Informal document GRVA-18-39  
18th GRVA, Geneva, 22-26 January 2024  
Provisional agenda item 9(b)

# UN Regulations No. 78

## Limitations and Improvements for S-EPAC

Fig. 2. CG positions of motorized vehicle, motor cycle, electric bicycle  
 Image sources: Daimler, Yamaha, Merida

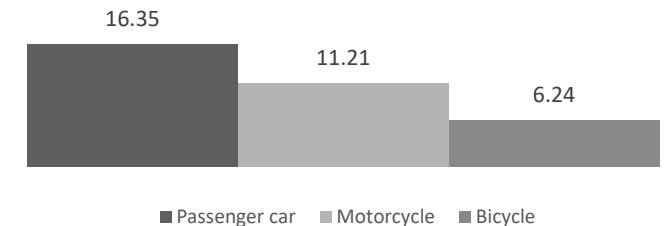
- The deceleration threshold of  $6.17\text{m/s}^2$  on high friction surface in UN R78 does not fit for bicycles physics (geometry, center of gravity, etc.)
- A brake efficiency of 100% is impossible in comparison to the rider's best values due to the working principle of ABS
- An ABS efficiency of 80-90% can be rated as very good and leads to a significant increase of stability and hence safety of the bike

- **Proposal:**
  - Changing the deceleration threshold definition from a vehicle independent one to a vehicle dependent one as in braking test "Stops on low friction surface" (chapter 9.4) enables a better fit of UNECE R78 to S-EPACs (cf. slide 3)
